Request for Information

ACQR #5905783 B141 Research Vehicle Storage RFP

CONTRACT NUMBER: ACQR # 5905783		REQUEST FOR INFORMATION		RFI NUMBER: 01	
CONTRACT TITLE: B141 Research Vehicle Storage					
PRIME CONTRACTOR: TANTARA Corp			SUBCONTRACTOR/SUPPLIER:		
SUBJECT/TITLE OF RFI: Fire Protection wet/dry system option needed for pricing

CONTRACT NUMBER: ACQR # 5905783		REQUEST FOR INFORMATION		RFI NUMBER: 02	
CONTRACT TITLE: B141 Research Vehicle Storage					
PRIME CONTRACTOR: TANTARA Corp			SUBCONTRACTOR/SUPPLIER:		
SUBJECT/TITLE OF RFI: Pre-Engineered building existing ret'g wall foundation

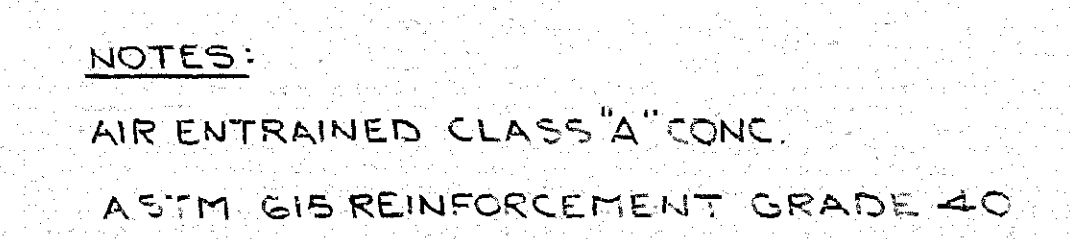
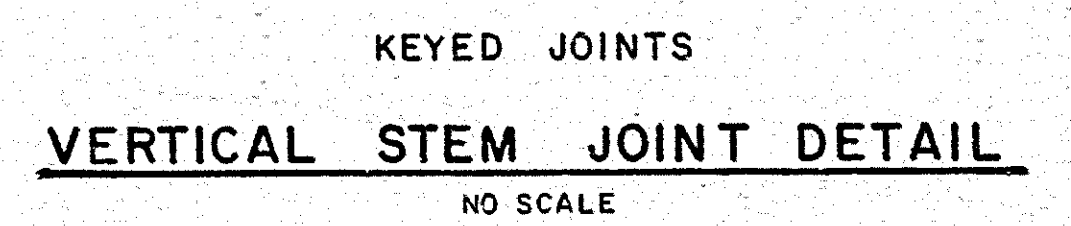
DRAWING(S):		DETAIL(S):	SPECIFICATION:		CPM ACTIVITY NUMBER:
COST EFFECT: INCREASE: <input type="checkbox"/> DECREASE: <input type="checkbox"/> NONE: <input checked="" type="checkbox"/>					
INFORMATION REQUESTED & RECOMMENDED SOLUTION:					
<p>The design intent of the project is to utilize the existing retaining walls as a foundation for the proposed pre-engineered building. Our building designer is going to need the existing structural design specifics for this wall so they can complete their building design accordingly.</p> <p>Please confirm structurally that these two retaining walls at 90 degrees to each other have sufficient capacity to support this structure without requiring any additional reinforcement. Please provide retaining wall design (footing design, reinforcement, wall thicknesses, concrete strength, etc.</p> <p>Date Response Required By: Date: 21JUN22Signature: Steven Pratt</p>

From: To: Field Office Code RECOMMENDATION:					
<div>See attached dwg of existing retaining wall construction.</div>					
Date: Signature:					
From: Field Office To: Prime Contractor REPLY:					
Date: Signature:					
<p>This reply is given with the expressed understanding that it does not constitute basis for change in the amount or time of subject contract. If you do not concur, DO NOT PROCEED, and notify this office immediately. Please assign PC # to this change. It is requested that a proposal be forwarded by . THIS DOES NOT CONSTITUTE AUTHORIZATION TO PROCEED.</p>					
copy to: File 2L Supv Civil Engineer Construction Representative
